M-9A0 (Calpella + N11P/M Discrete Graphic)

FOXCONN		HON HAI Precision Ind. Co., Ltd.	
Title		ARD(Power)	
Size	Document Number	Rev	
Custom	M9A0 MP	1.1	
Date:	Wednesday, October 28, 2009	Sheet	5 of 73

FOXCONN		HON HAI Precision Ind. Co., Ltd.	
		CCPBG - R&D Division	
Title	PCH (PCI-E, SMBUS, CLK)		
Size	Document Number	Rev	
Custom	M9A0 MP	1.1	
Date:	Friday, October 23, 2009	Sheet	10 of 73

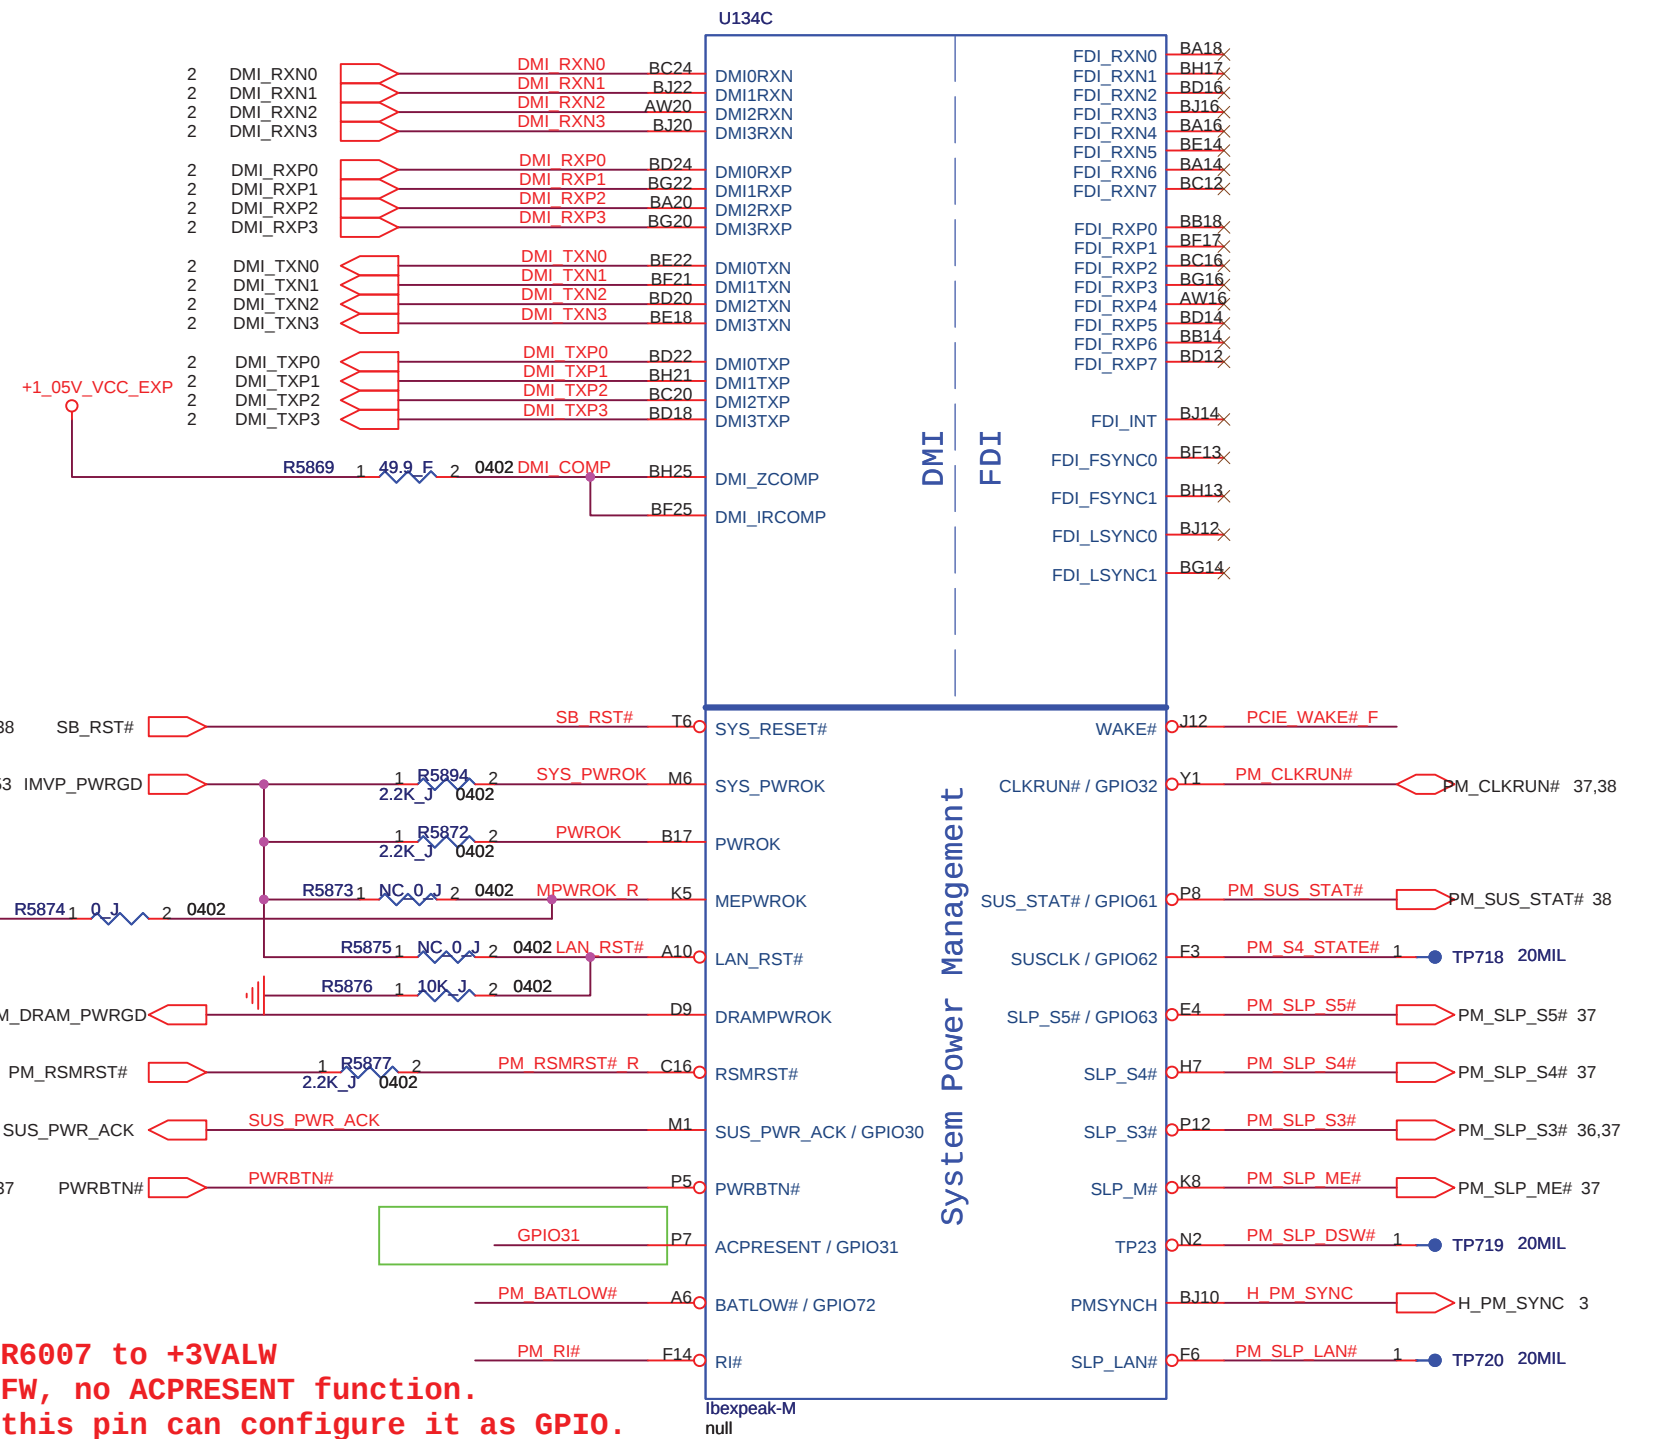
2009.0928
Add the Q7 as MOR request.

2009/09/10 (DVT2)
Delete R5893, add R6007 to +3VALW
M9A0 use Ignition FW, no ACPRESENT function.
Intel FAE suggest this pin can configure it as GPIO.

2009/09/10 (DVT2)
Delete R5887 and Net name AC_Present
M9A0 use Ignition FW, no ACPRESENT function.
Intel FAE suggest this pin can configure it as GPIO.

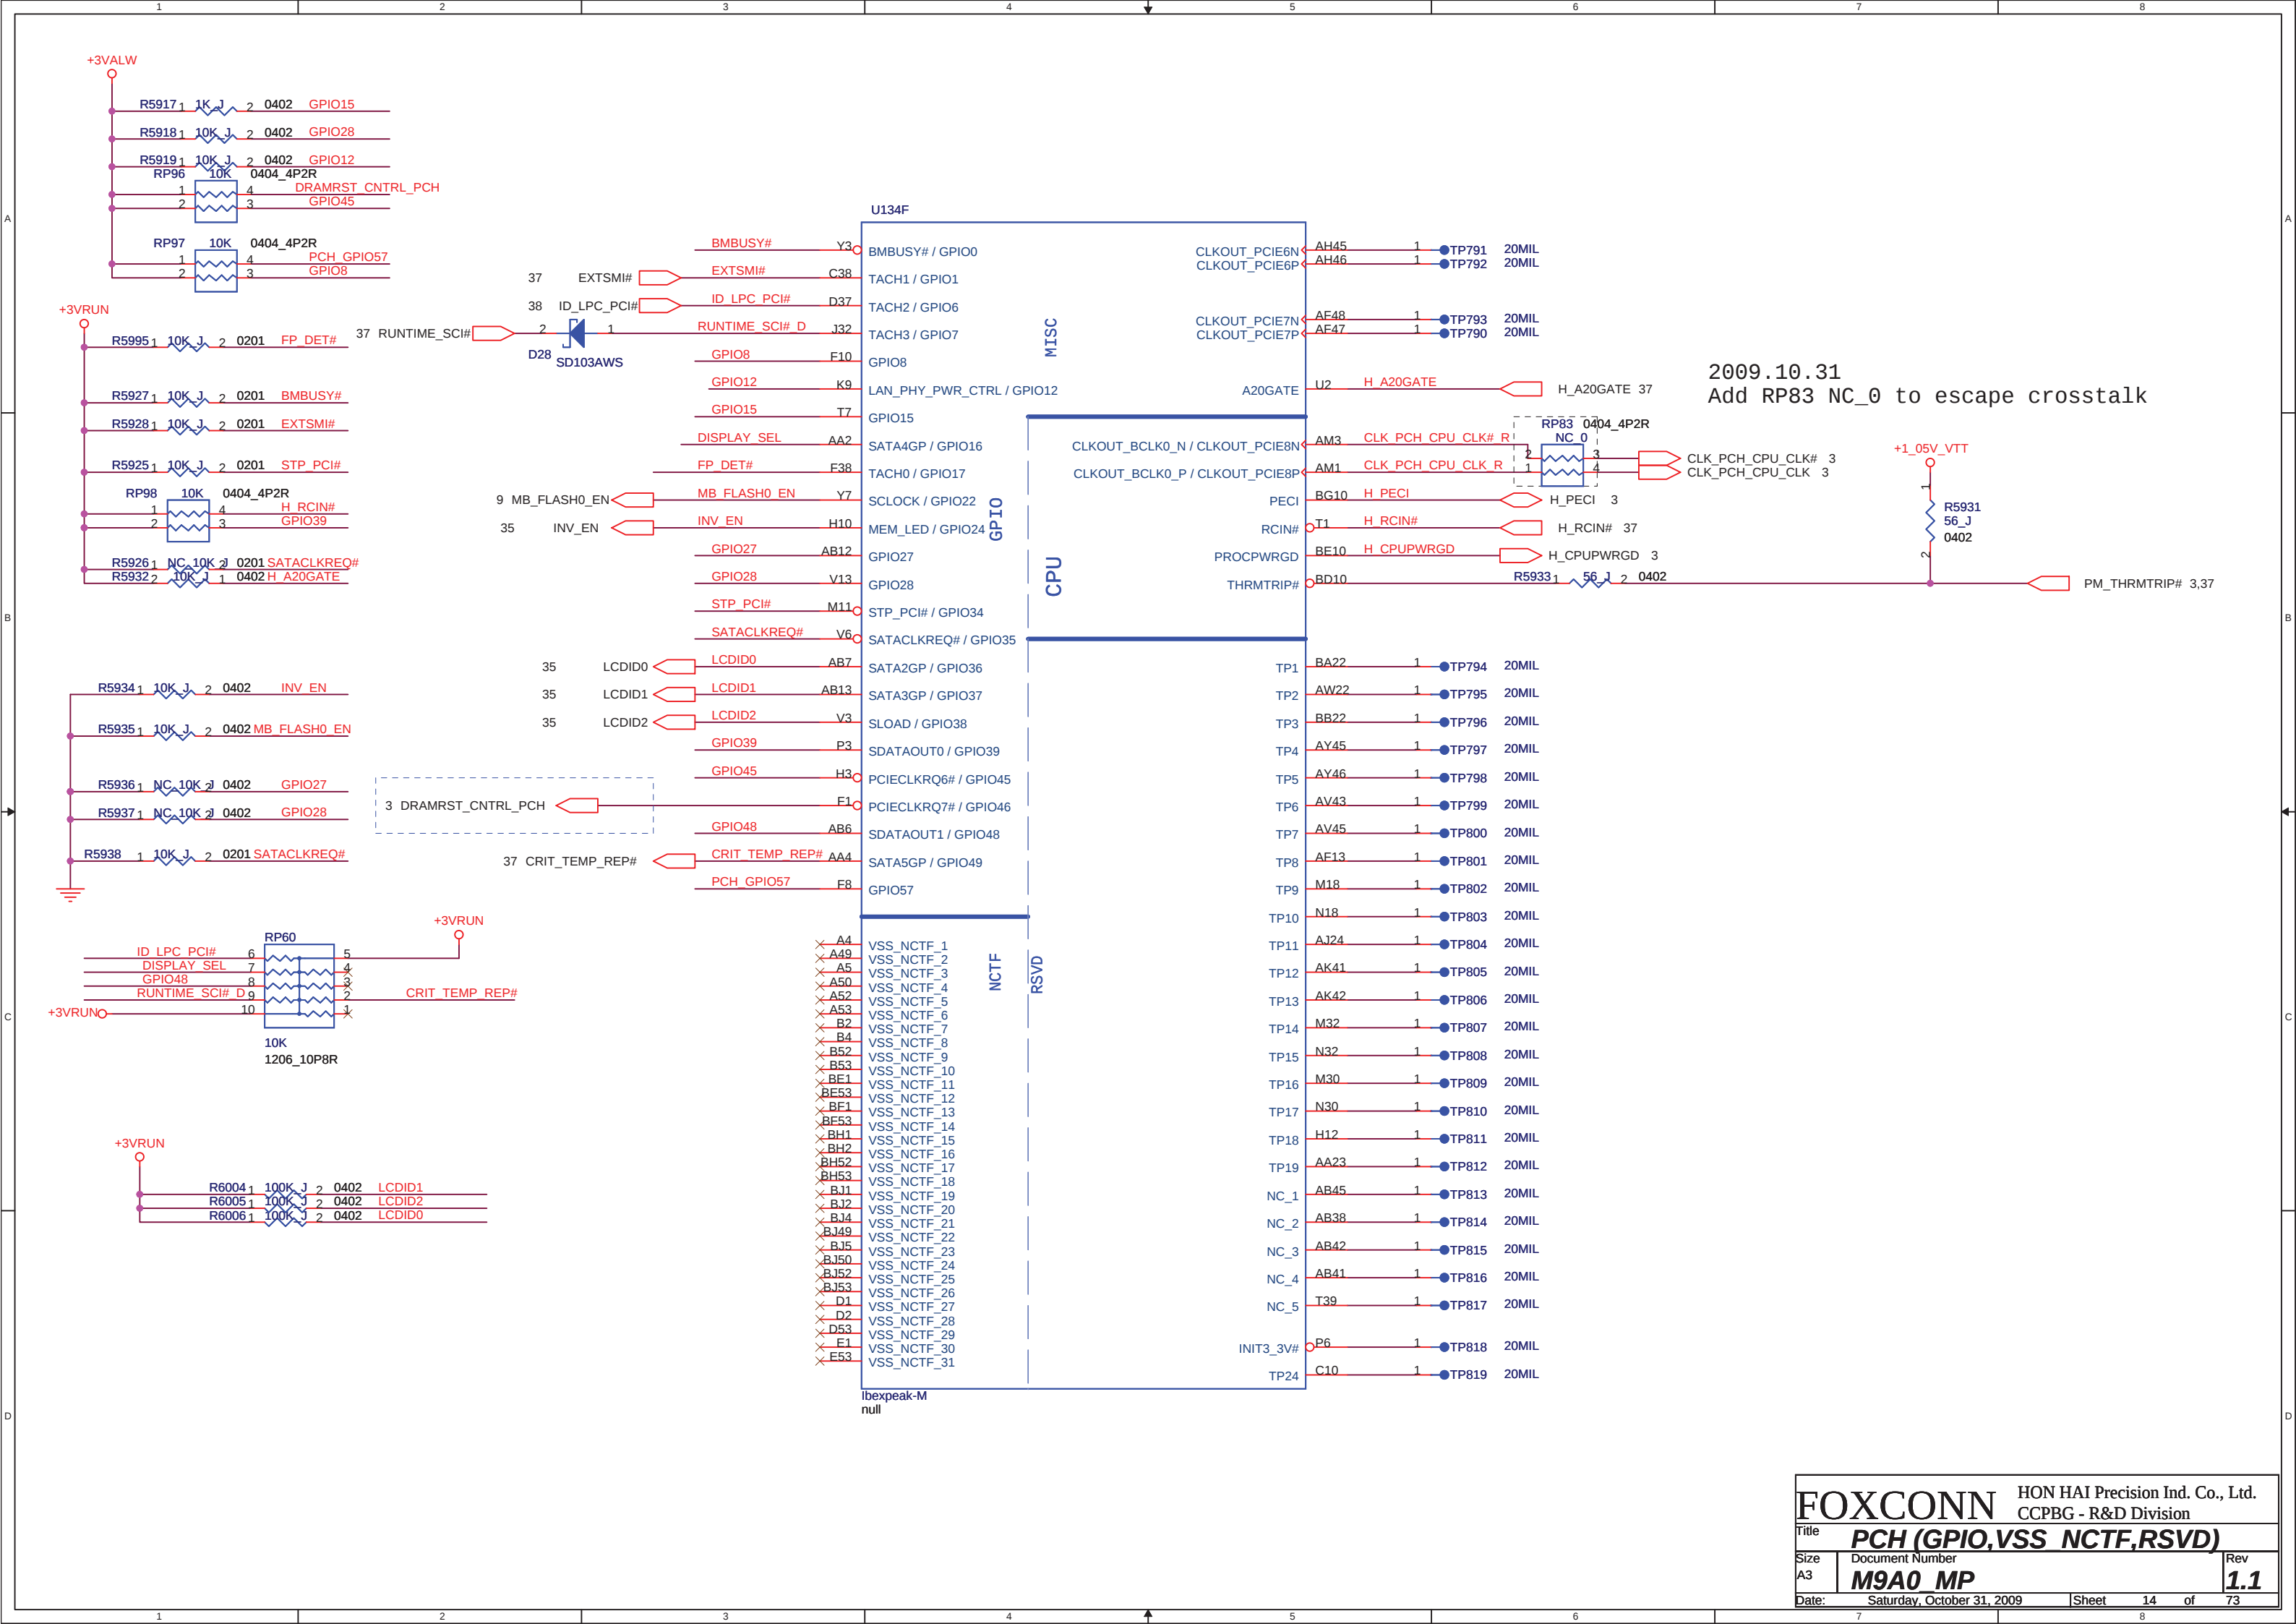
2009.10.31
Add RP83 NC_0 to escape crosstalk

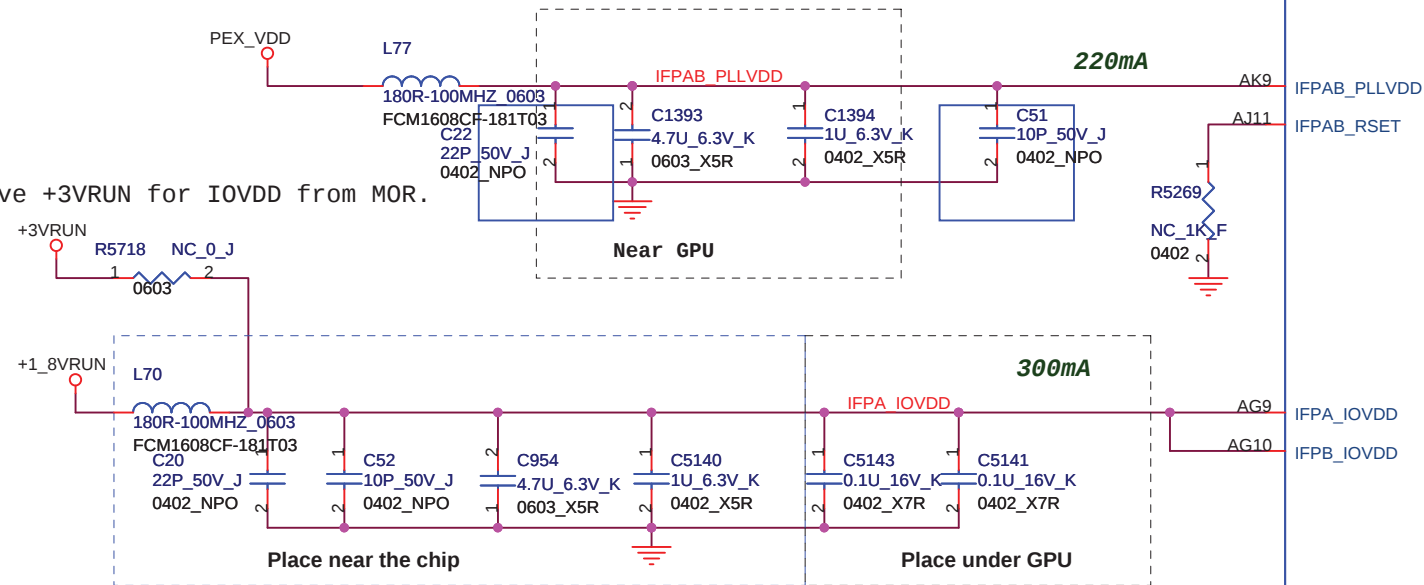
08/12/26 Add C51,C52 10p follow RF propose.

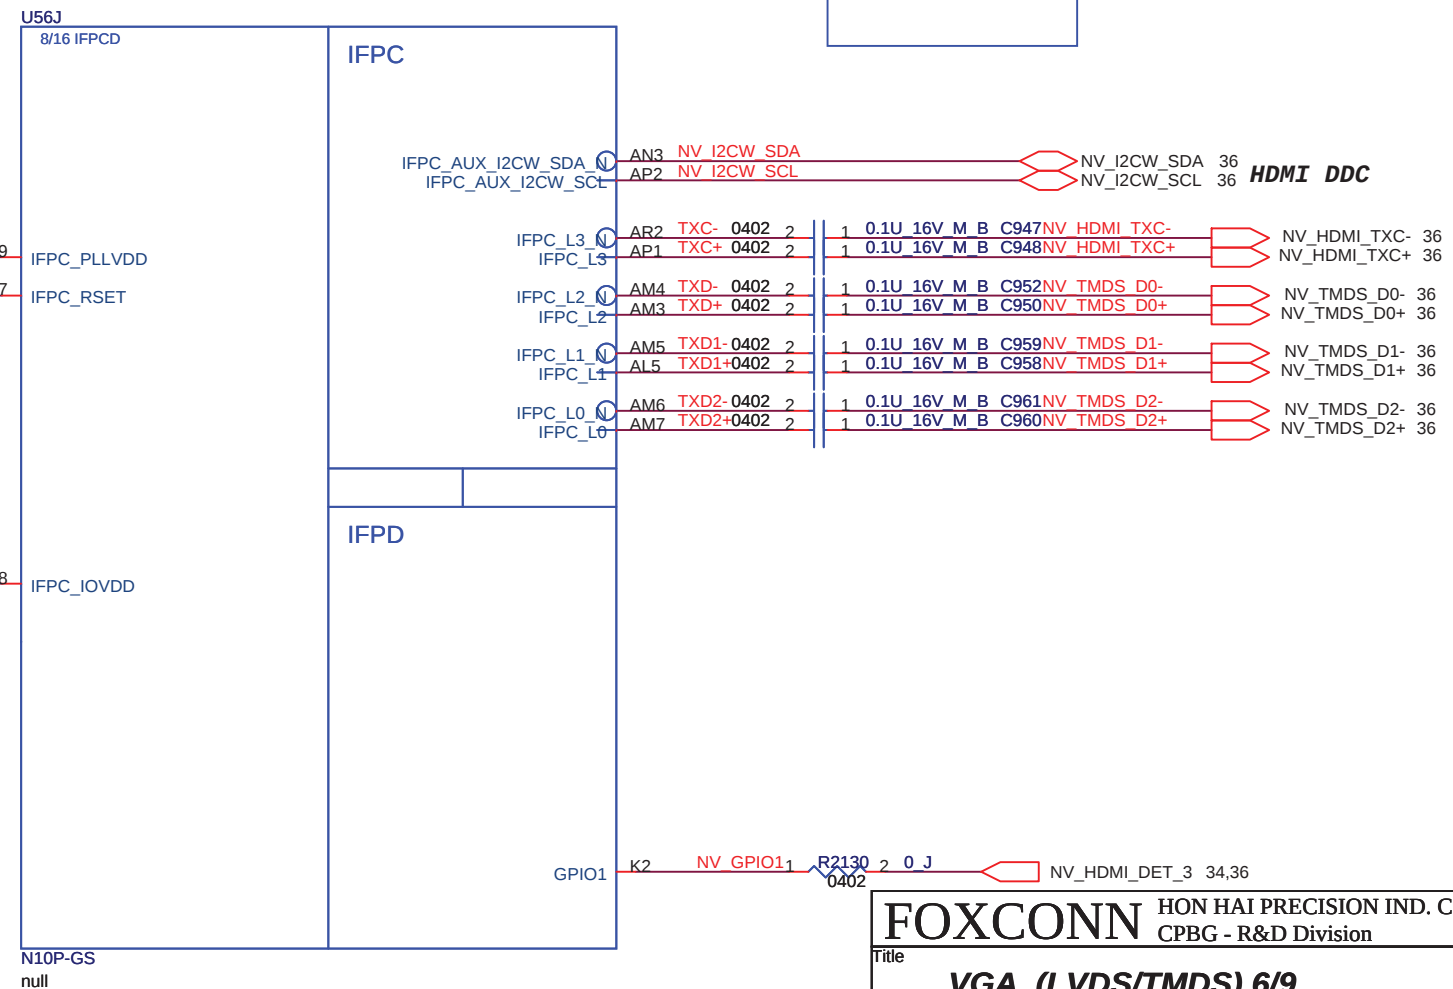
08/12/22 Change R1056,R1057 from 2.2K to 3.9K follow Mor-side propose.
